THE APPLICATION OF U.S. 60 WATER DISTRICT	}	
OF SHELBY AND FRANKLIN COUNTIES, KENTUCKY)	
FOR A CERTIFICATE OF PUBLIC CONVENIENCE)	NO. 2014-00101
AND NECESSITY TO CONSTRUCT PURSUANT TO)	
THE PROVISIONS OF KRS 278.020 AND KRS 278.300)	
)

RESPONSES TO COMMISSION STAFF'S SECOND REQUEST FOR INFORMATION

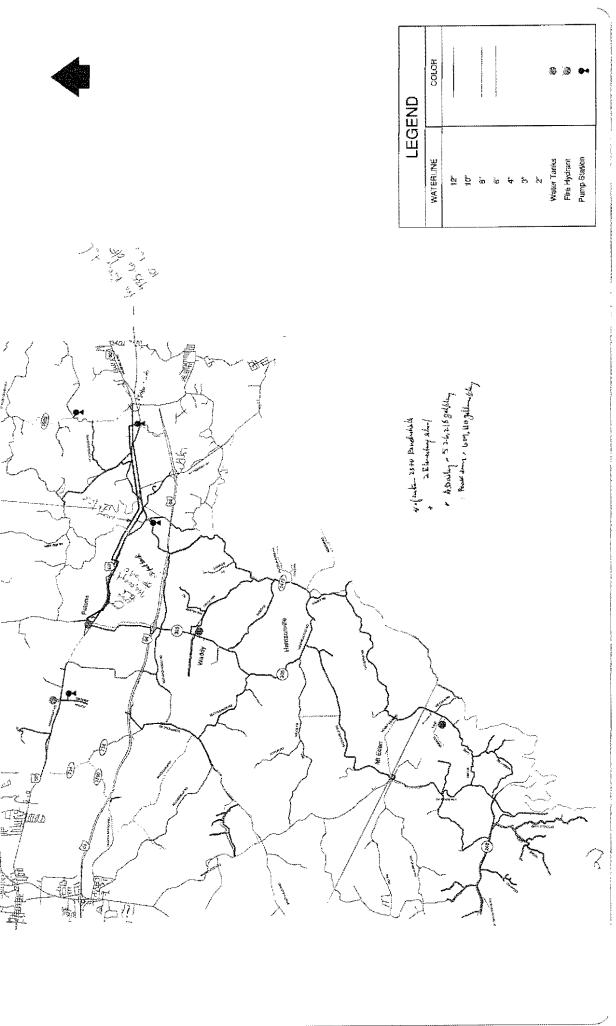
3. For each existing storage tank in the system, provide the name of the tank, type of the tank, whether it is elevated or a standpipe, total storage volume and effective storage capacity in gallons, and the pressure zone to which it belongs. Tabulate the results.

Response:

TANK NAME	TYPE	NOMINAL VOLUME	EFFECTIVE VOLUME	PRESSURE
				ZONE
Driscoll	Elevated	200,000 gallons	200,000 gallons	Same
Clay Village	Standpipe	97,167 gallons	7,773 gallons	Same
Waddy	Standpipe	177,000 gallons	60,685 gallons	Same
Peytona	Standpipe	132,200 gallons	40,982 gallons	Same
